**ADDENDUM
NO. 01**

July 31, 2024

Renovation of Fall Creek Intermediate School
12011 Olio Road
Fishers, IN 46038

CONSTRUCTION DOCUMENTS
 07.12.2024
 MWJ JOB NO.
 23055
 DRAWN BY
 MHS
 DRAWING NAME
**FIRST FLOOR
 ELECTRICAL PLAN -
 AREA C**
 DRAWING NO.
EP1-3

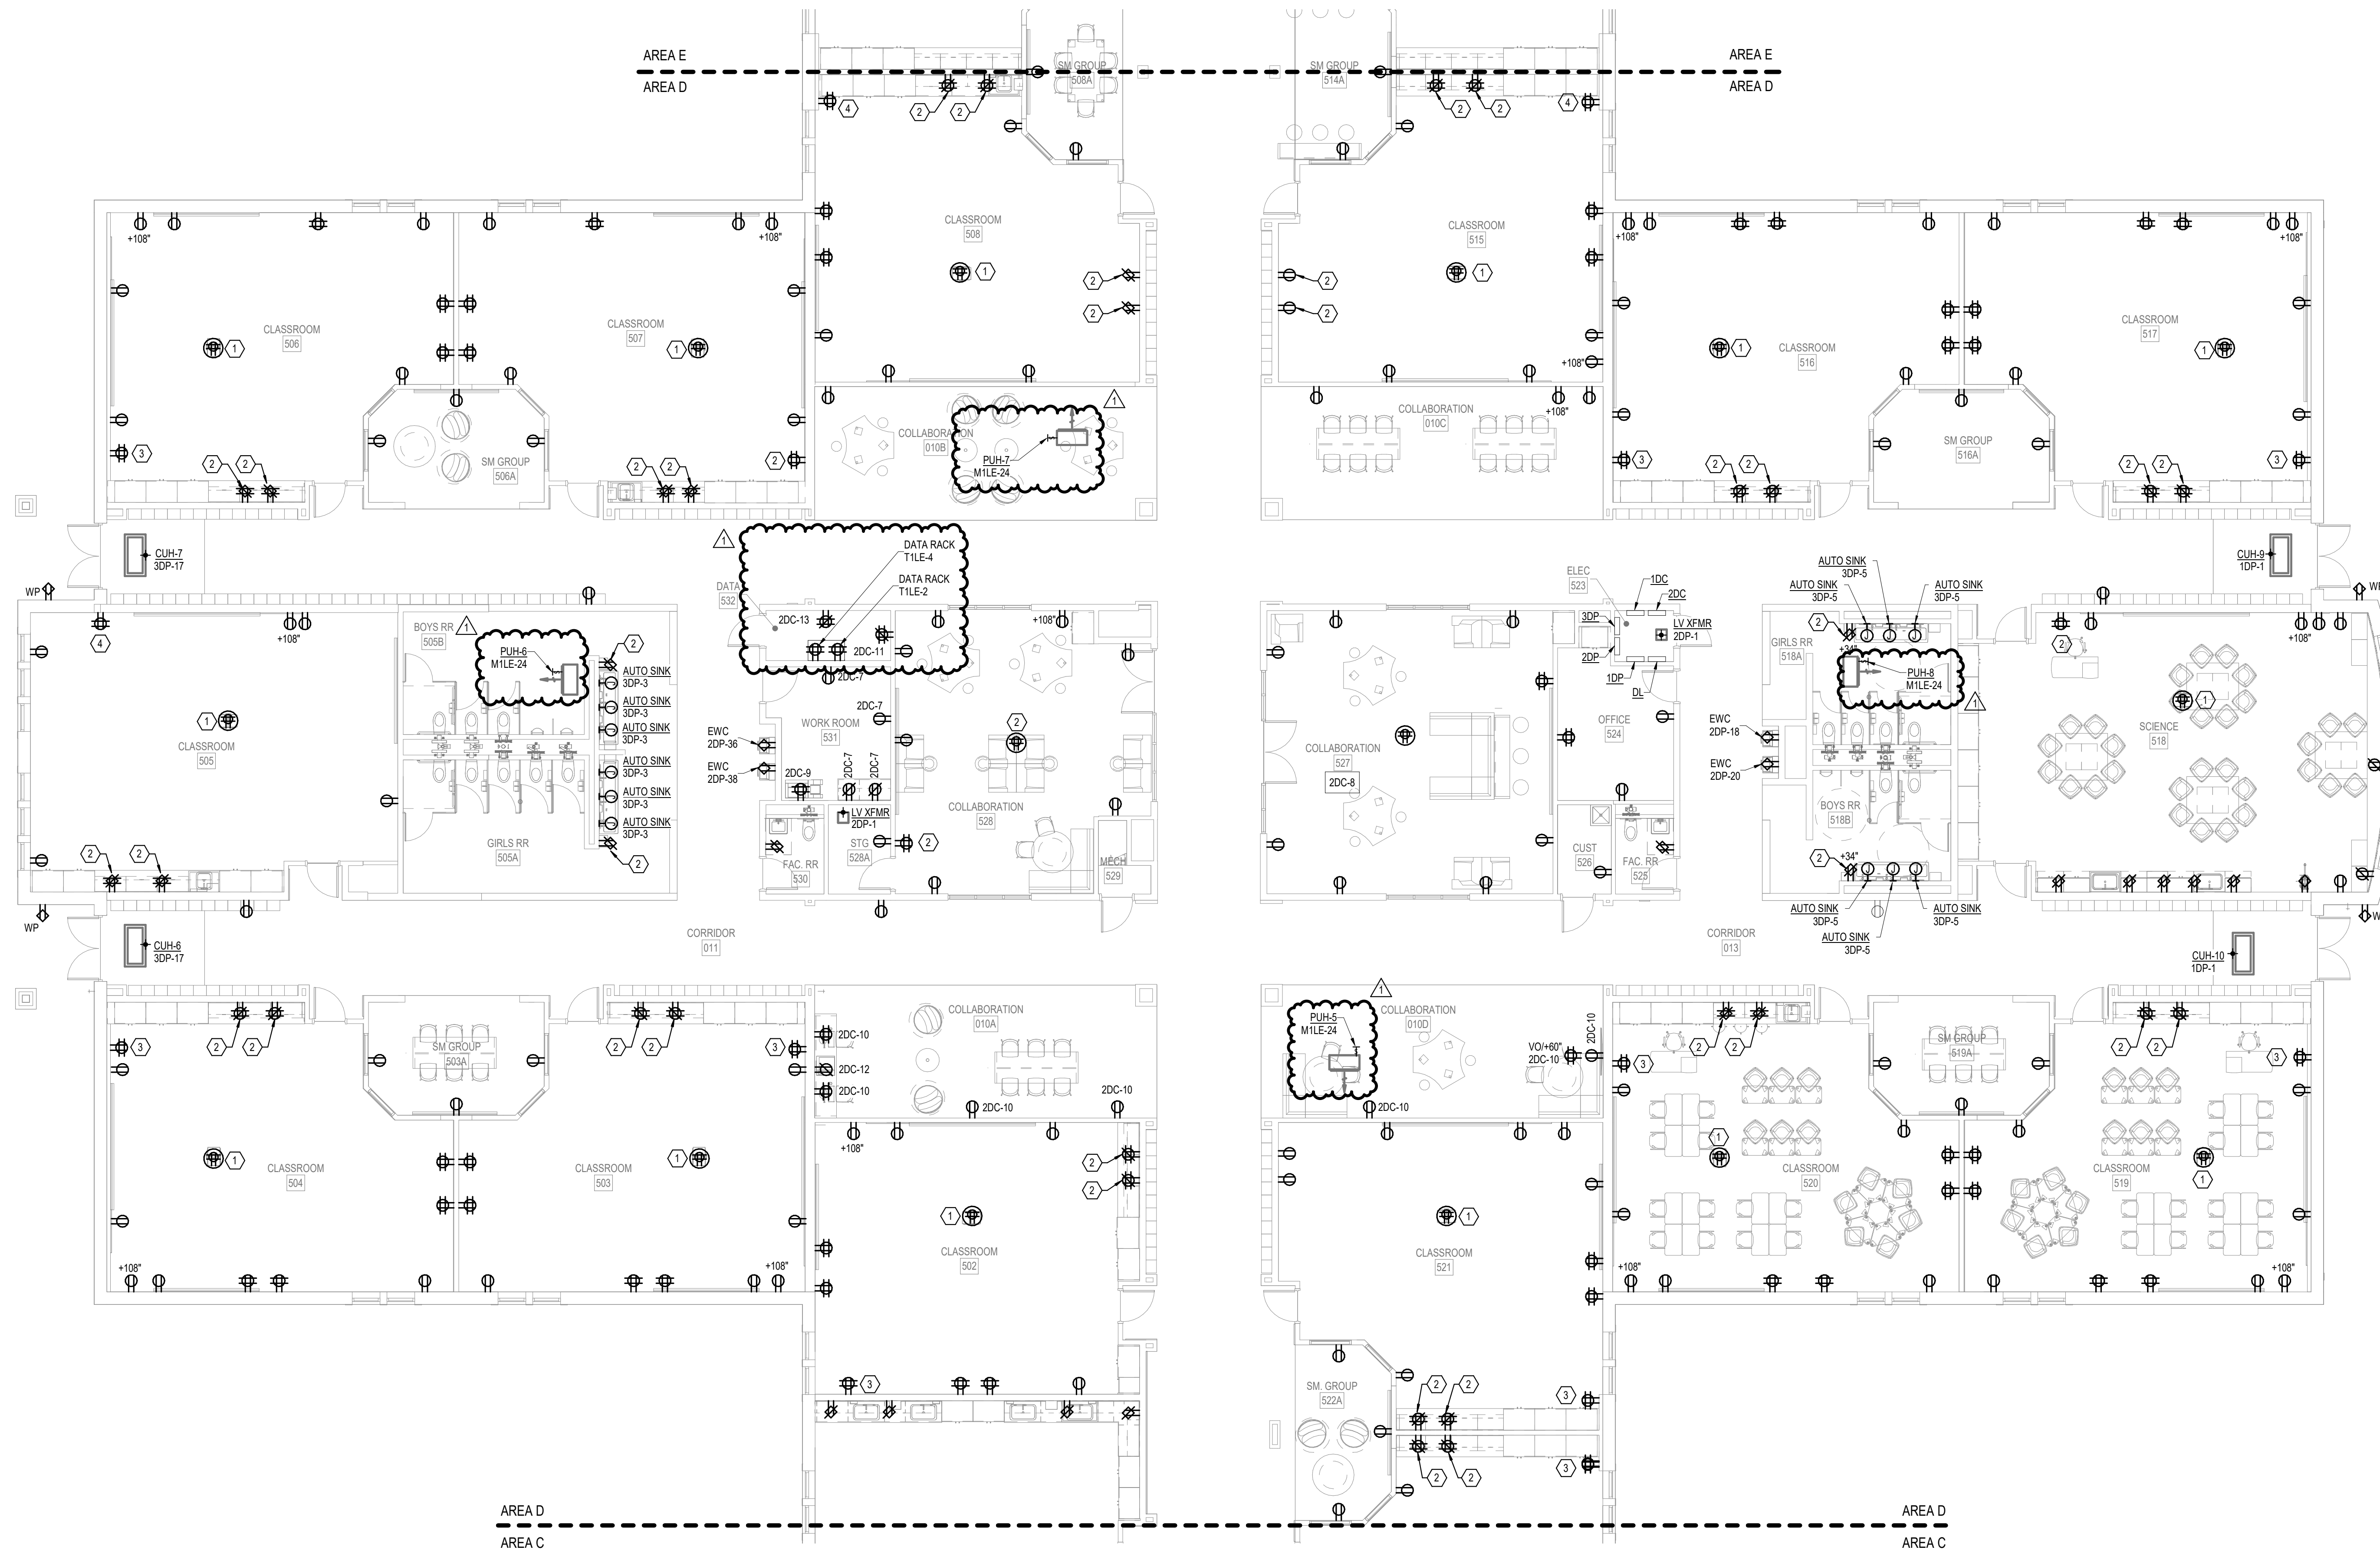
Sheet EP1-3

1. Revised electrical power device layout in MDF and IDF data rooms.
2. Revised circuit numbers for equipment shown.

CONSTRUCTION DOCUMENTS
 07.12.2024
 W/L JOB NO.
 23055
 DRAWN BY
 DCH
 DRAWING NAME
FIRST FLOOR ELECTRICAL PLAN - AREA F
 DRAWING NO.
EP1-5

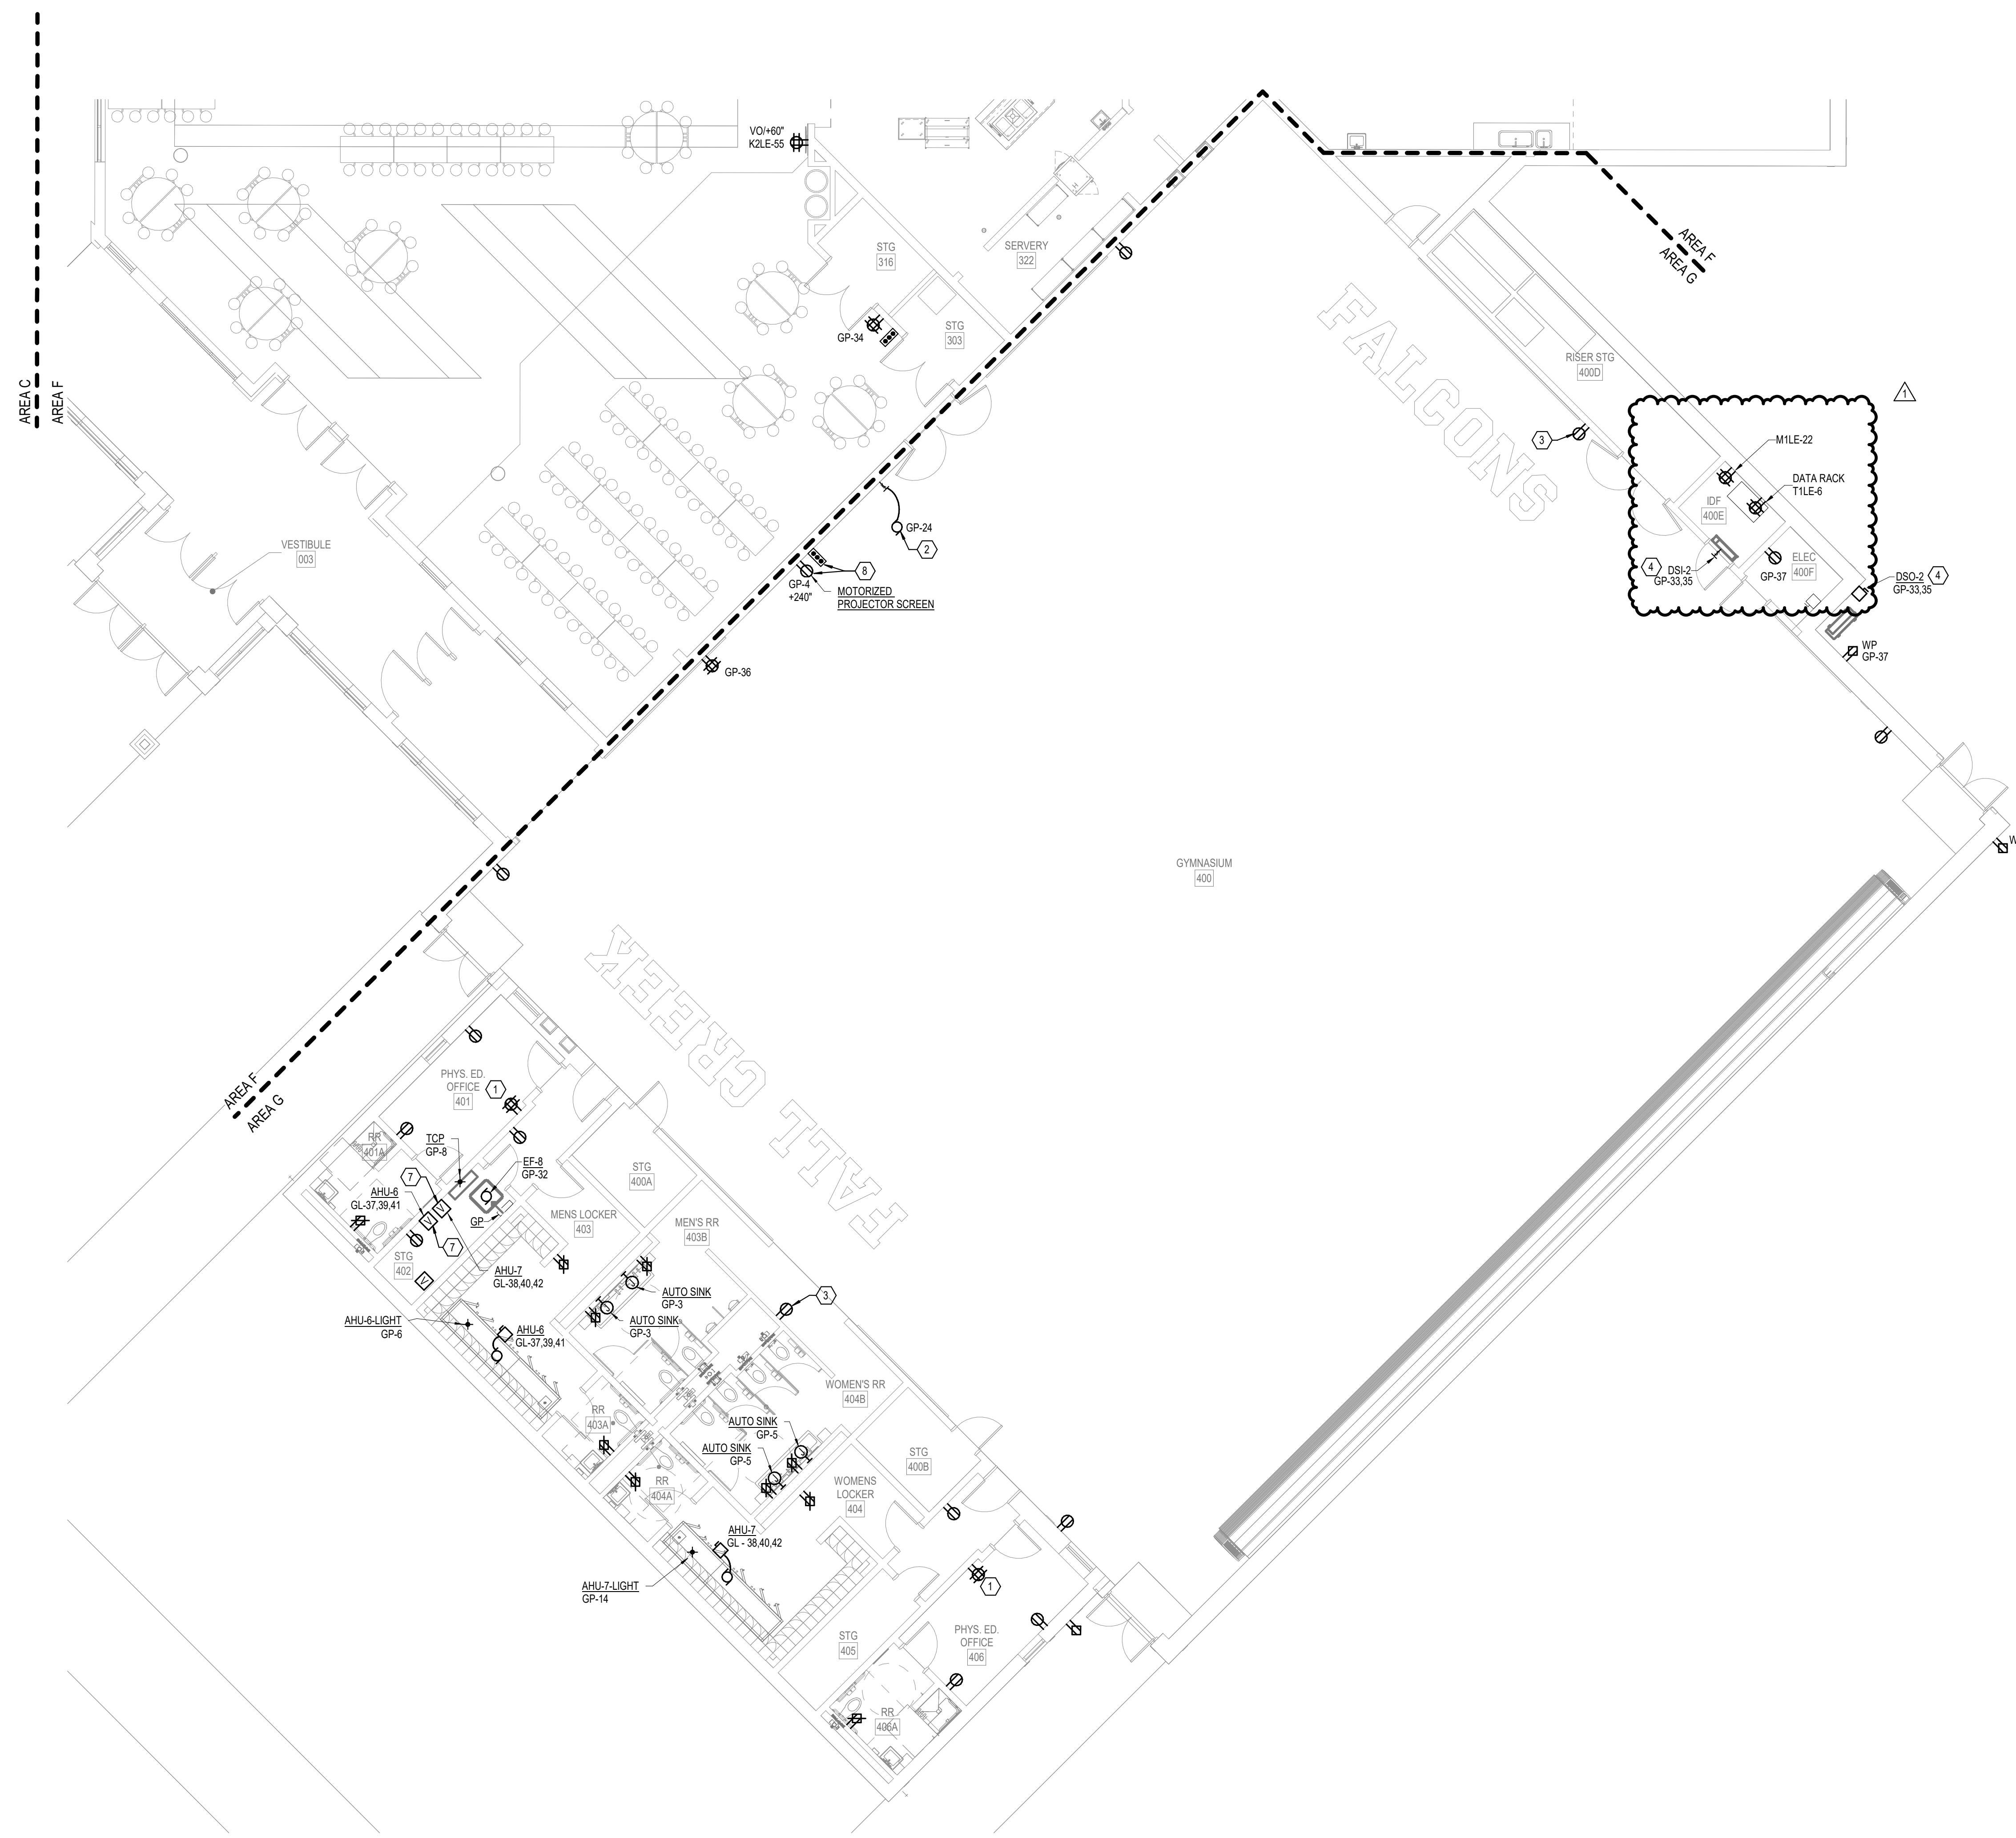
Sheet EP1-5

1. Revised circuit numbers for equipment shown.

CONSTRUCTION DOCUMENTS
07.12.2024
WNL JOB NO.
23055
DRAWN BY
MHS
DRAWING NAME
FIRST FLOOR ELECTRICAL PLAN - AREA G
DRAWING NO.
EP1-6

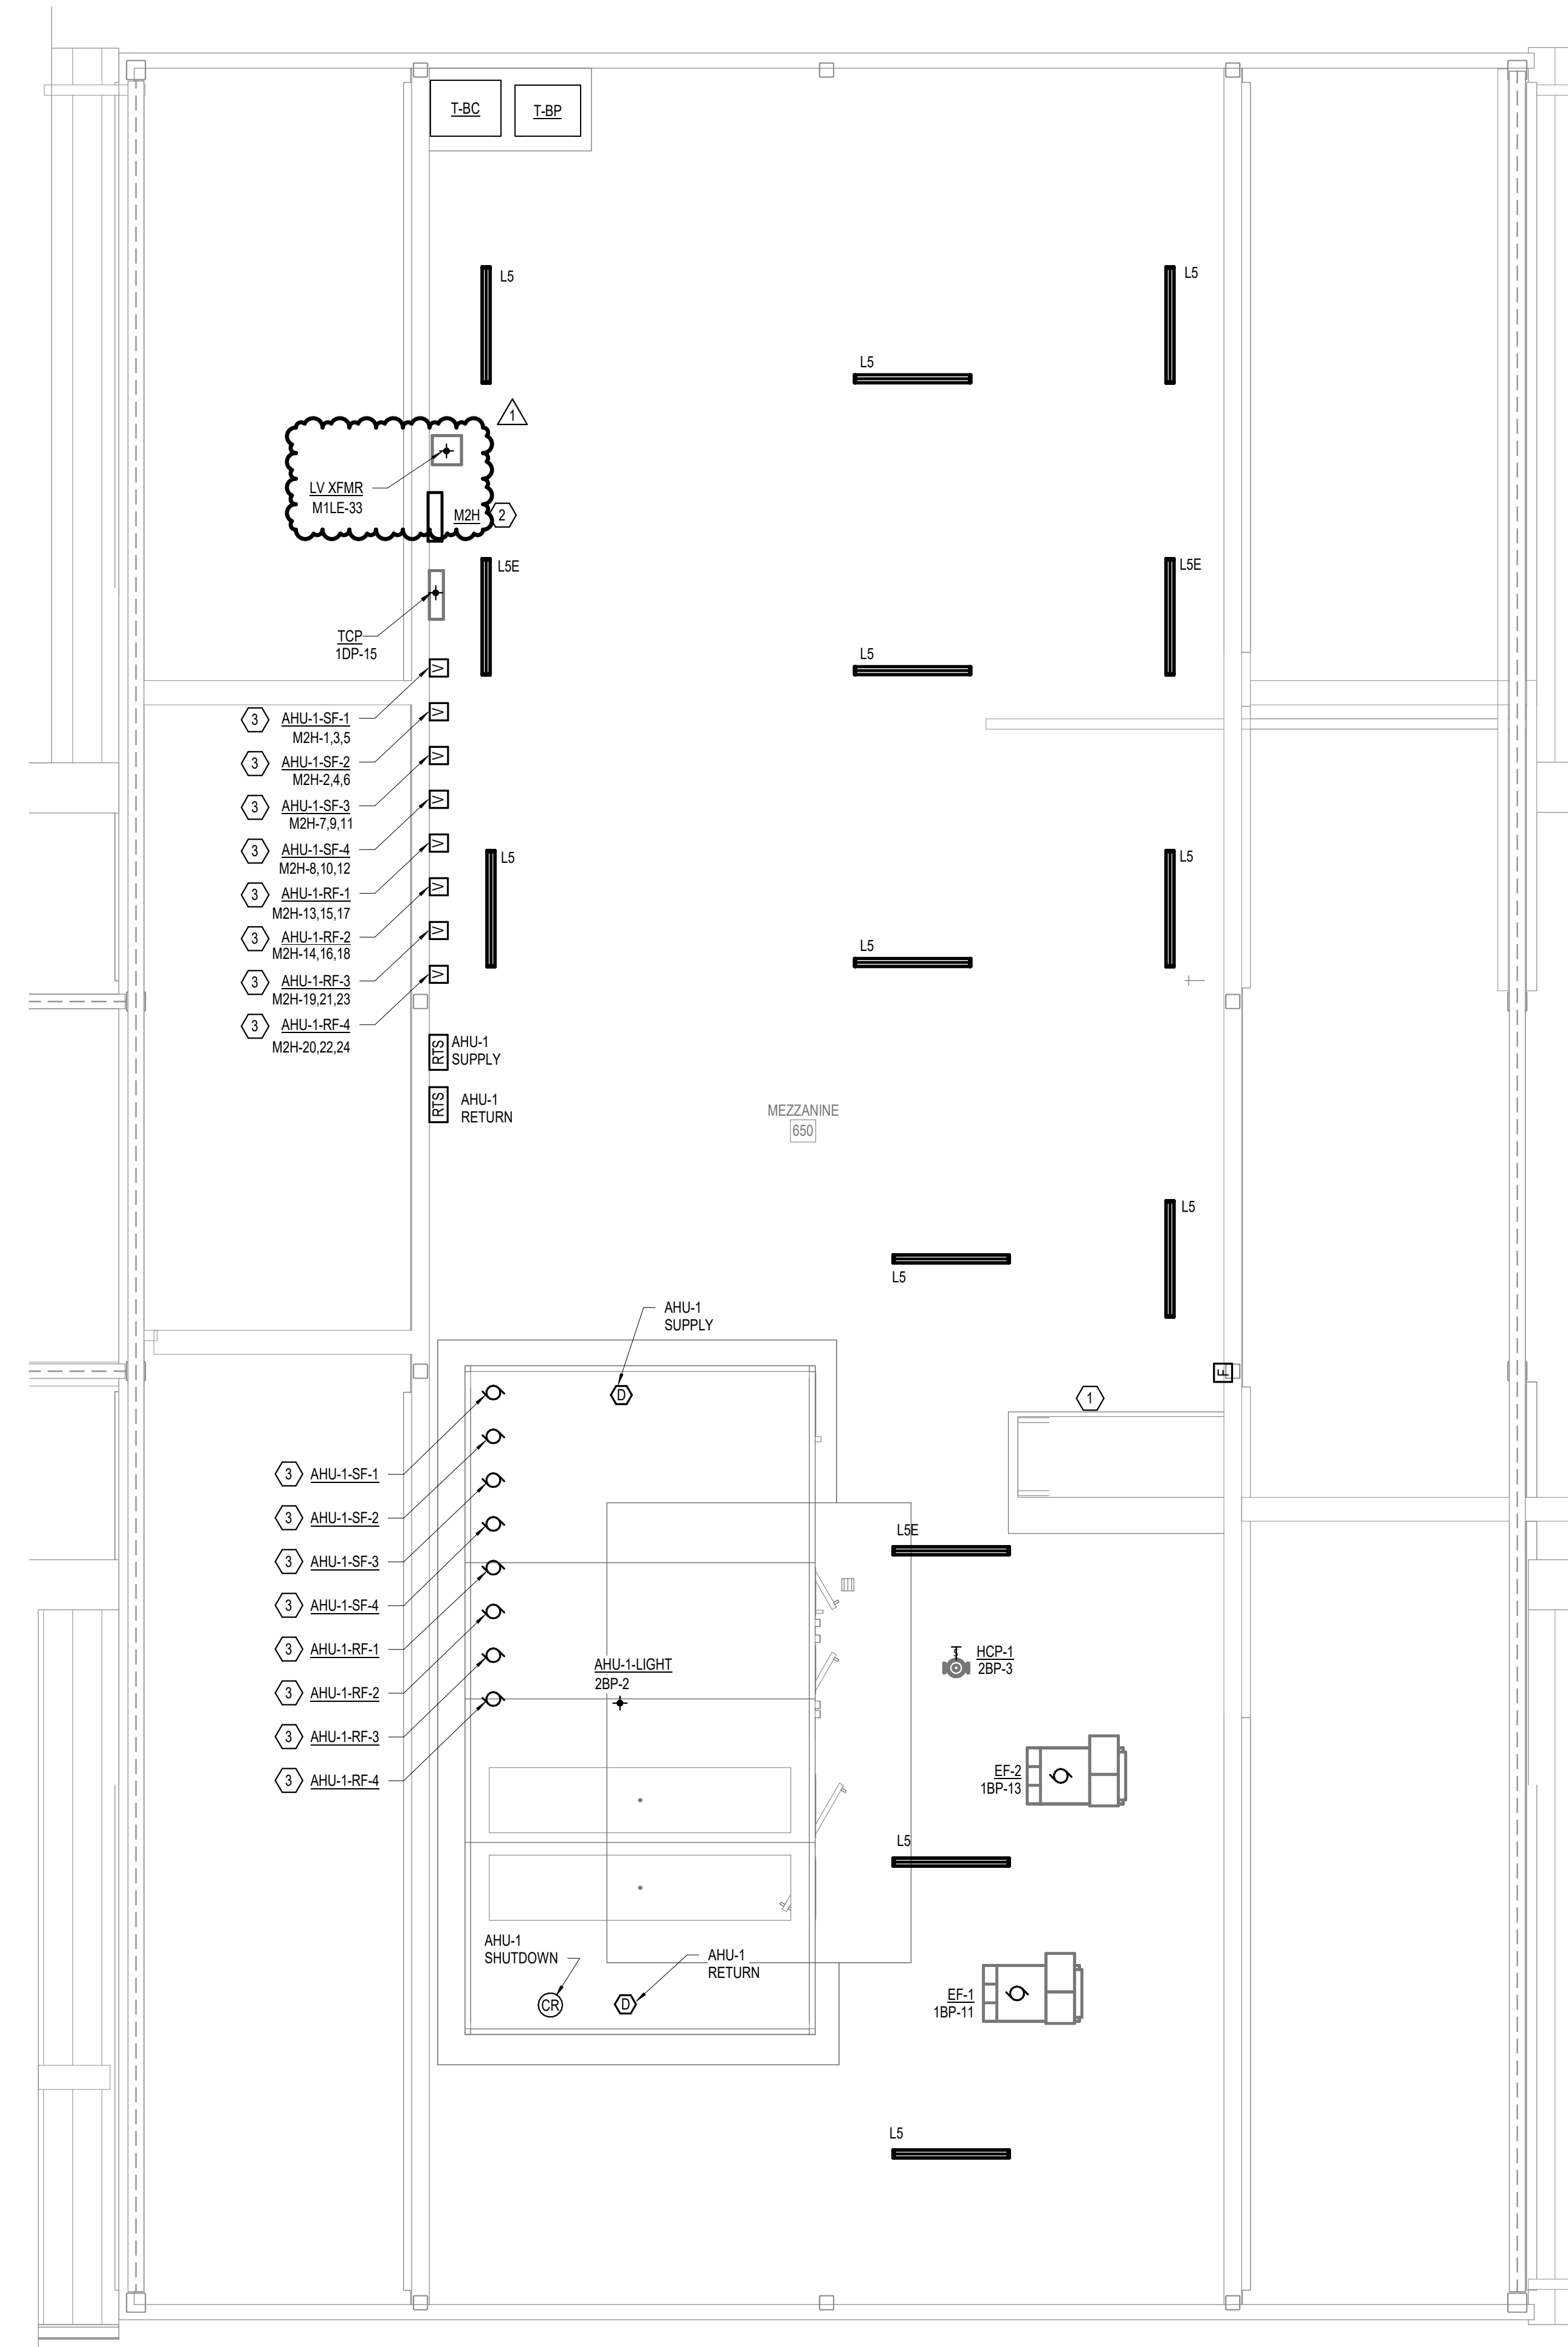
Sheet EP1-6

1. Revised electrical power device layout in the IDF room.
2. Revised circuit numbers for equipment shown.
